WATER DISTRIBUTION SYSTEM to serve
WESTAR SERVICE CENTER

WEBB BUSINESS PARK
 4025 N. TOBEN ST.
 CITY OF WICHITA, KANSAS

**AS BUILT PLANS
 CONTRACTOR: DONDLINGER CONSTRUCTION
 FOREMAN: BILL BUDD
 INSPECTED BY: JACOB MORRIS/SCHWAB EATON
 PDF BY: JCM 03/15/17**

Sheet Name:
3" DOMESTIC WATER LINE
Sheet No:
02

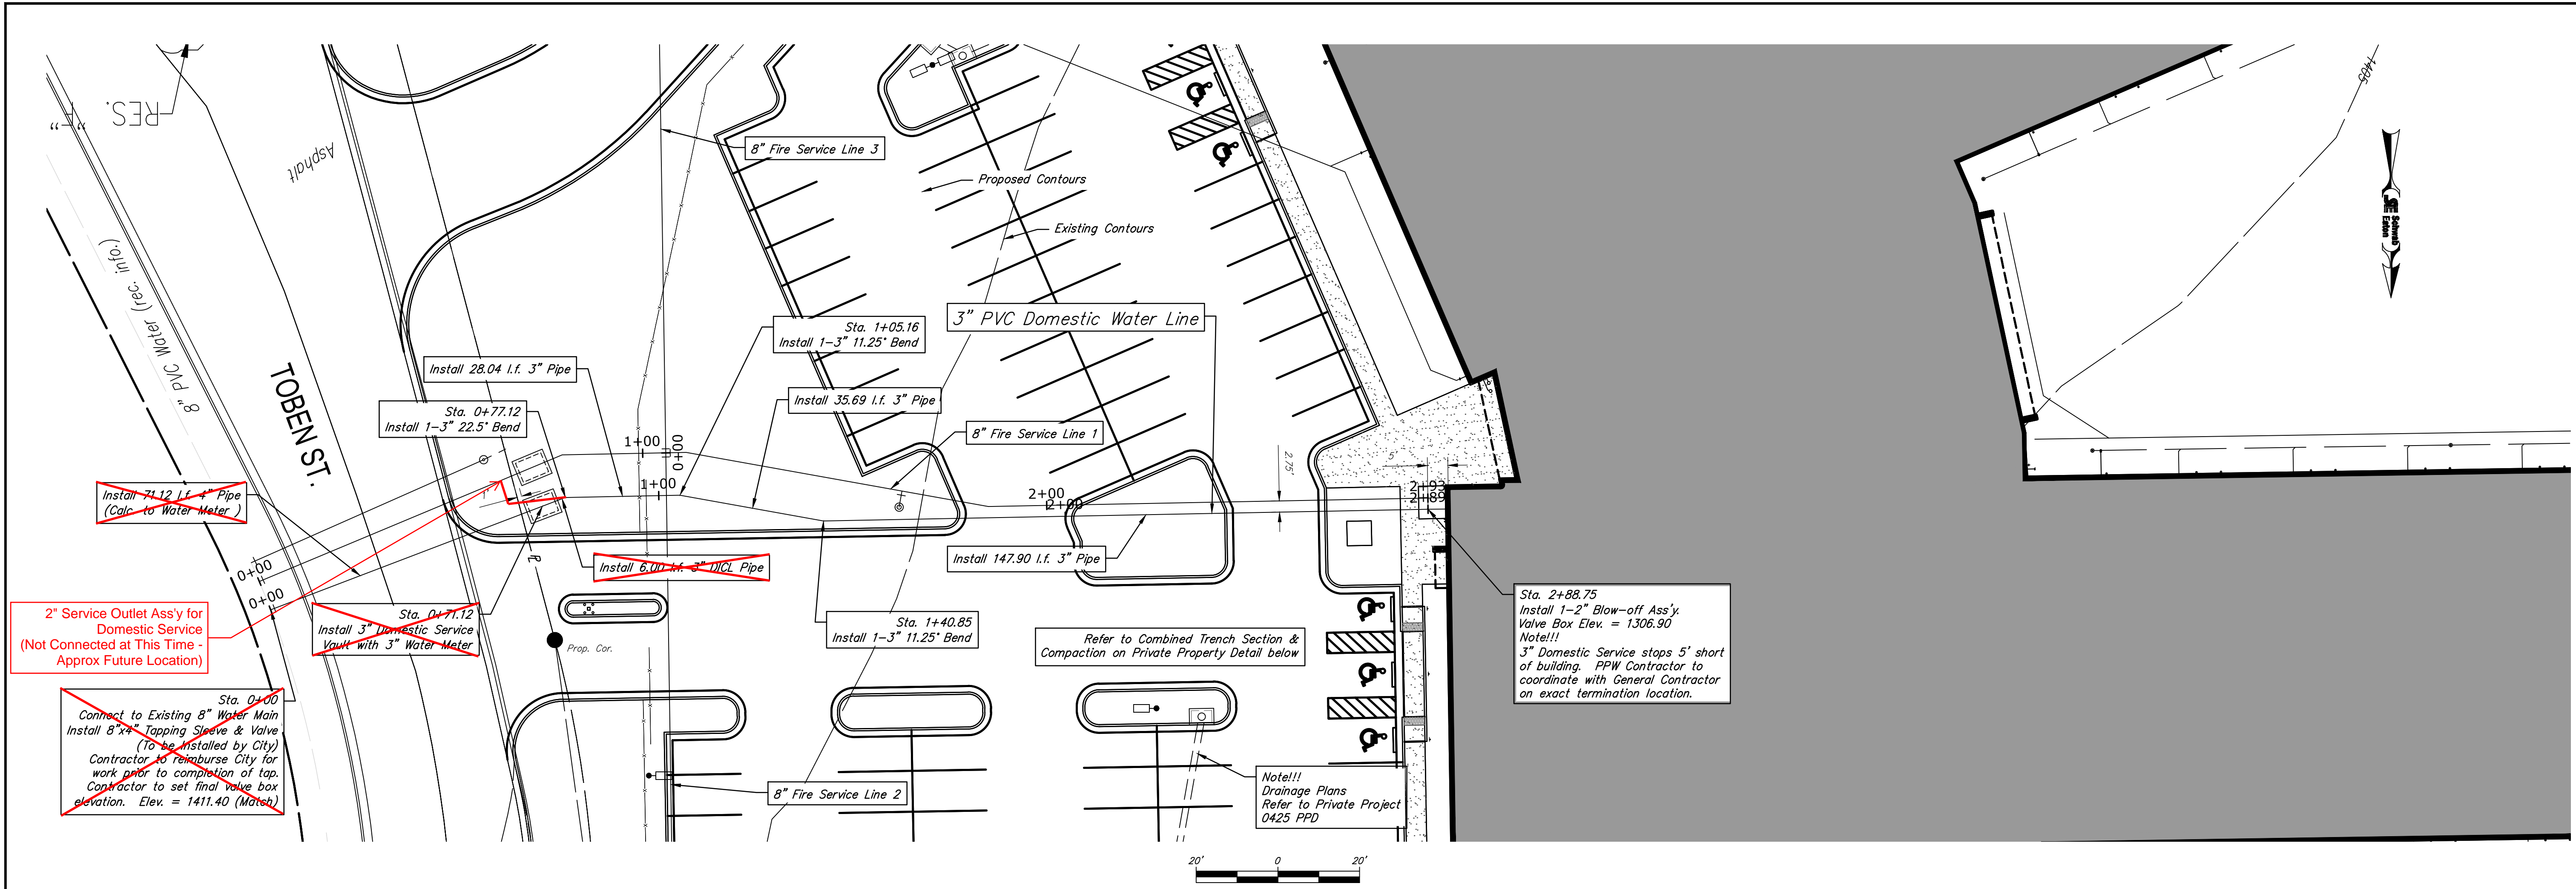
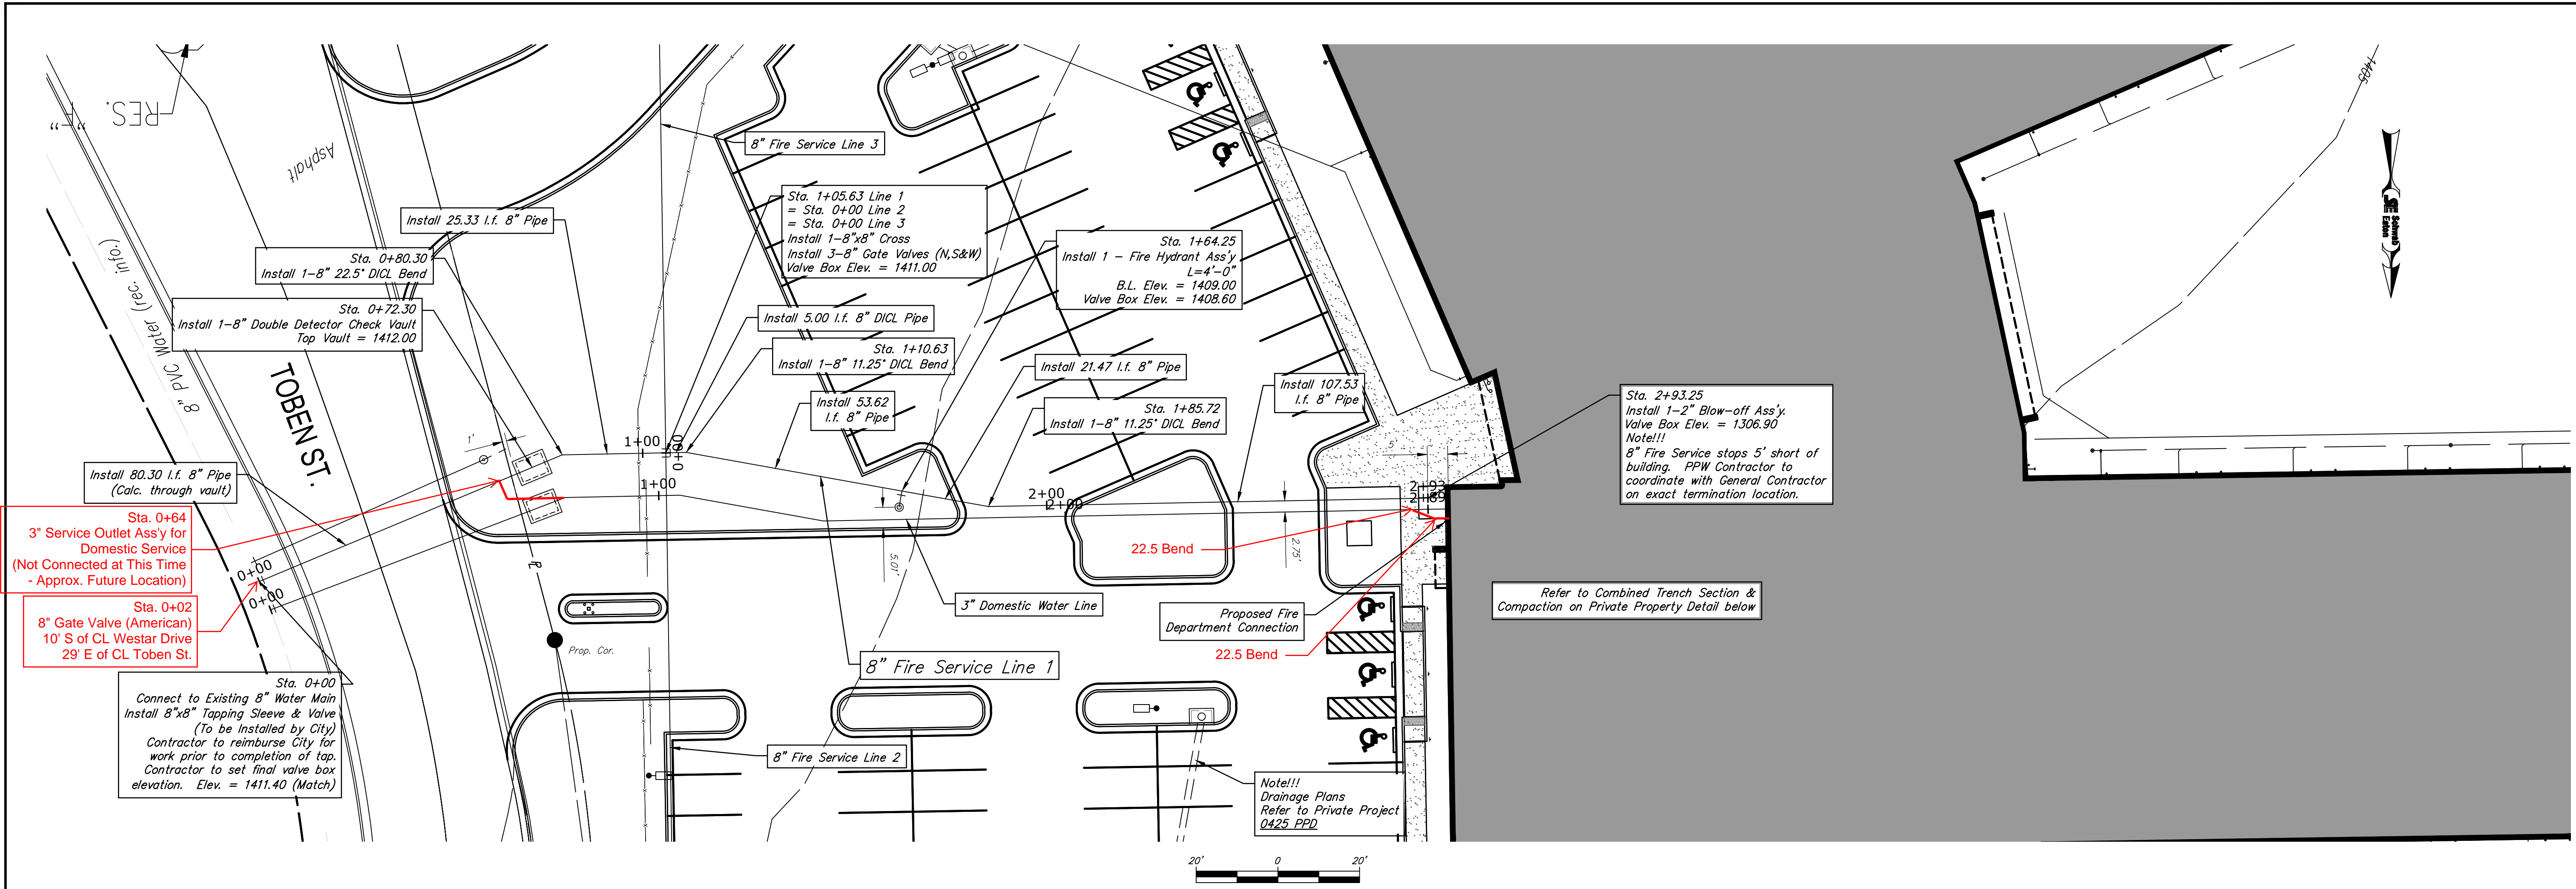
~~Sta. 0+00 Connect to Existing 8" Water Main Install 8"x4" Tapping Sleeve & Valve (To be installed by City) Contractor to reimburse City for work prior to completion of tap. Contractor to set final valve box elevation. Elev. = 1411.40 (Match)~~

~~Install 71.12 l.f. 4" Pipe (Calc. to Water Meter)~~

~~Sta. 0+77.12 Install 3" Domestic Service Vault with 3" Water Meter~~

Install 28.04 l.f. 3" Pipe
Sta. 0+77.12 Install 1-3" 22.5' Bend

Install 35.69 l.f. 3" Pipe
Sta. 1+05.16 Install 1-3" 11.25' Bend

Install 147.90 l.f. 3" Pipe
Sta. 1+40.85 Install 1-3" 11.25' Bend

Sta. 2+88.75 Install 1-2" Blow-off Assy Valve Box Elev. = 1306.90 Note!!! 3" Domestic Service stops 5' short of building. PPM Contractor to coordinate with General Contractor on exact termination location.

Sheet Name:
 8" FIRE SERVICE LINE 3
 STA. 5+50 TO
 STA. 9+37.99
 Sheet No:
R07

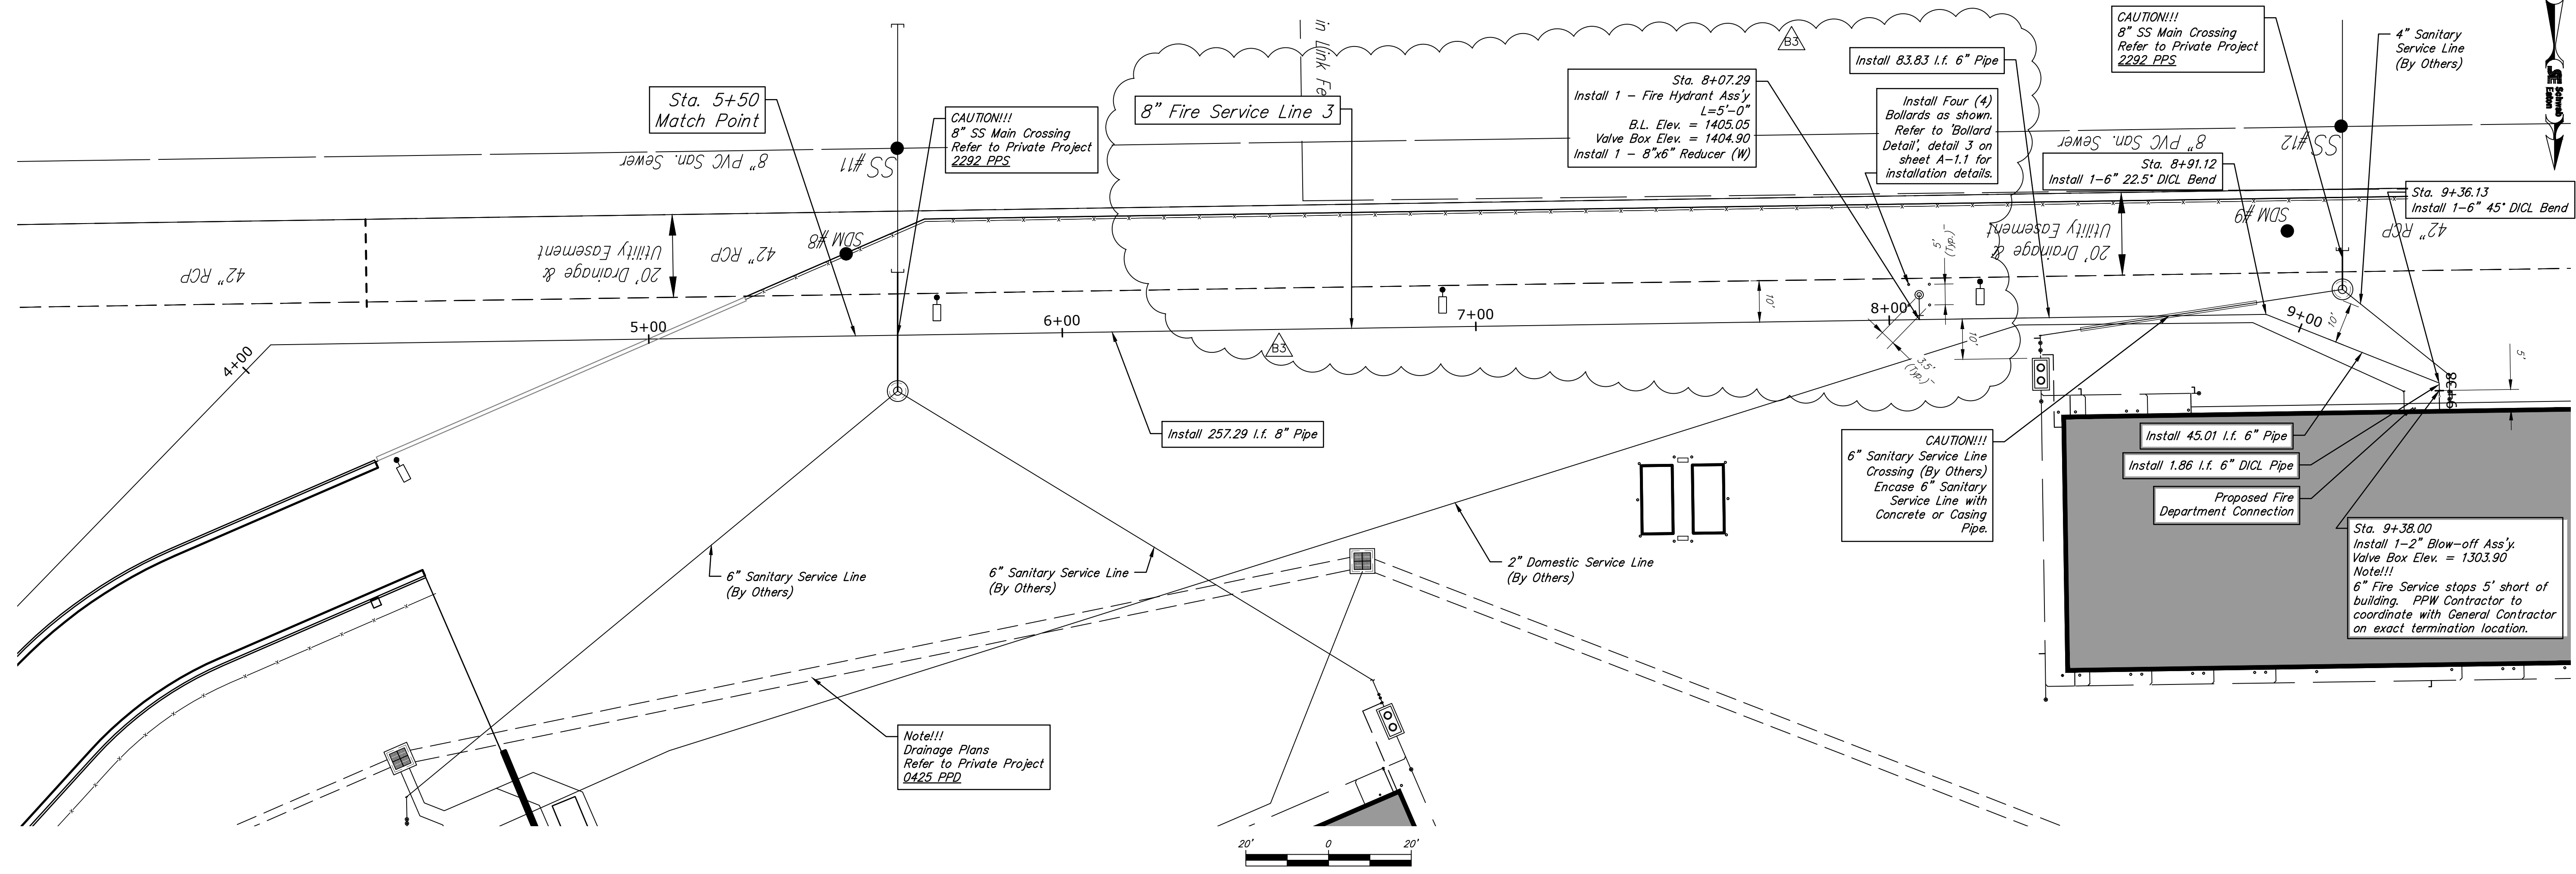
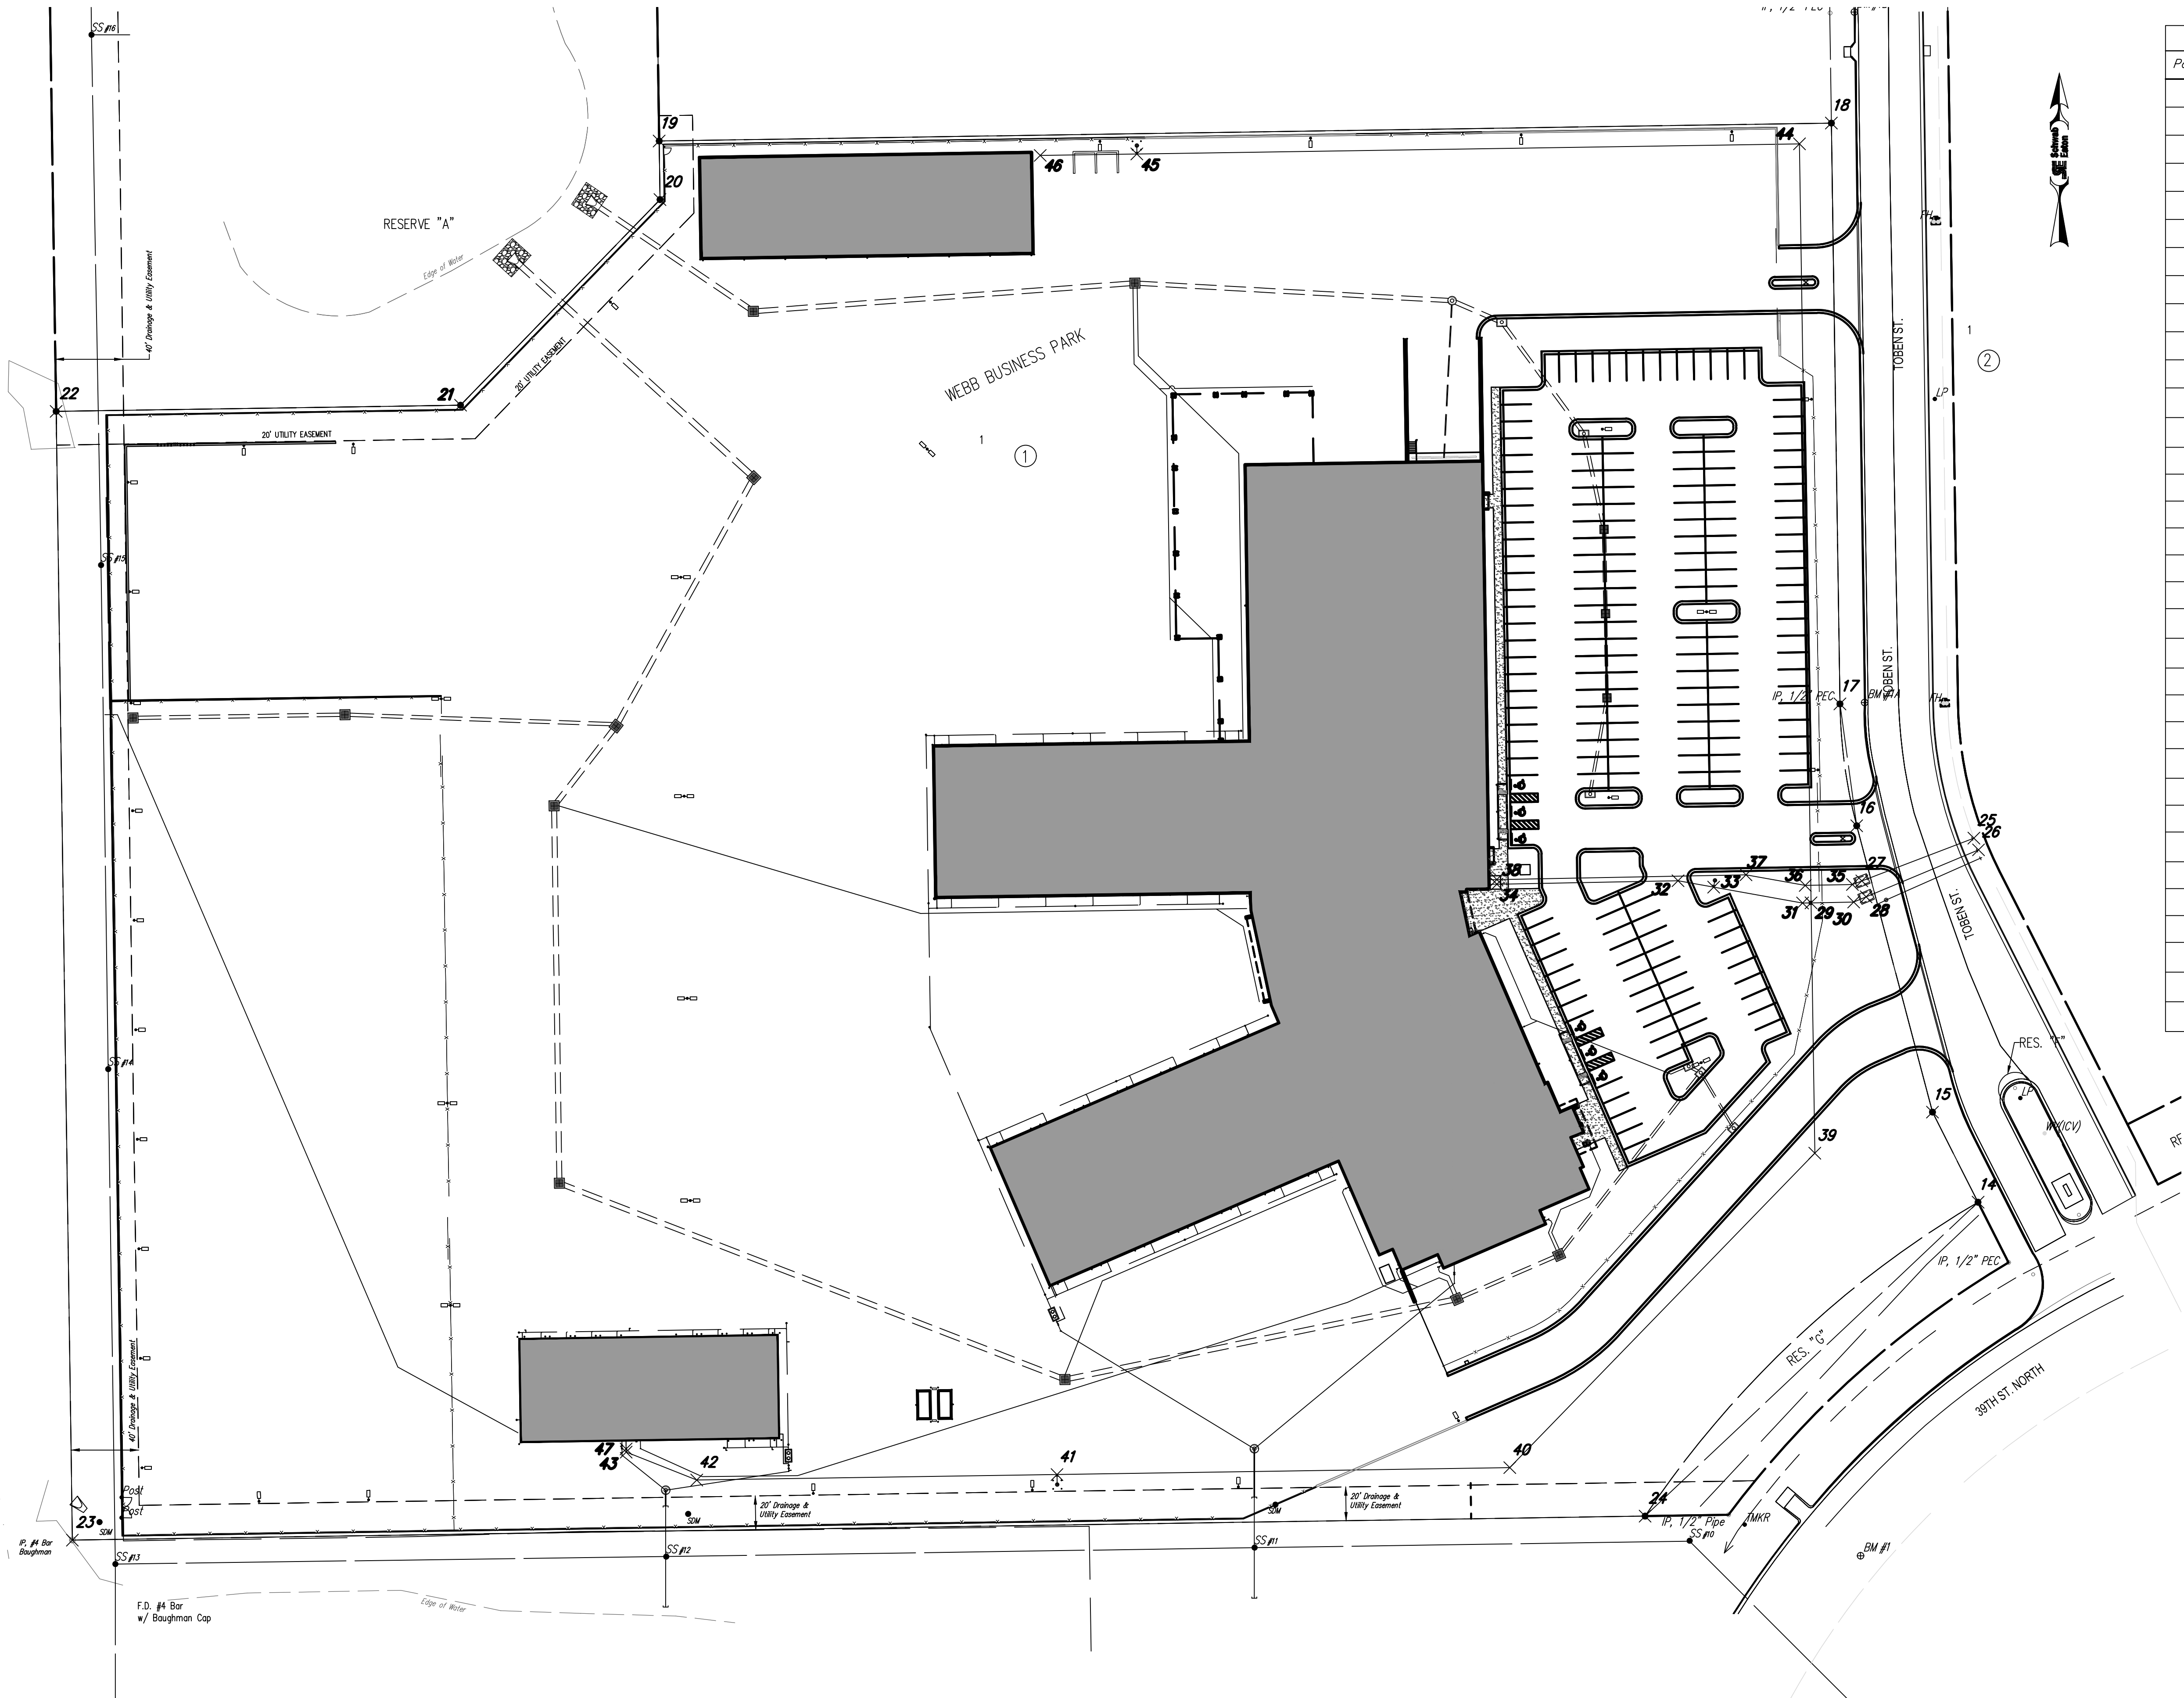
Revisions:
 2/27/2017
 MABCD PLAN REVIEW
 RESPONSE
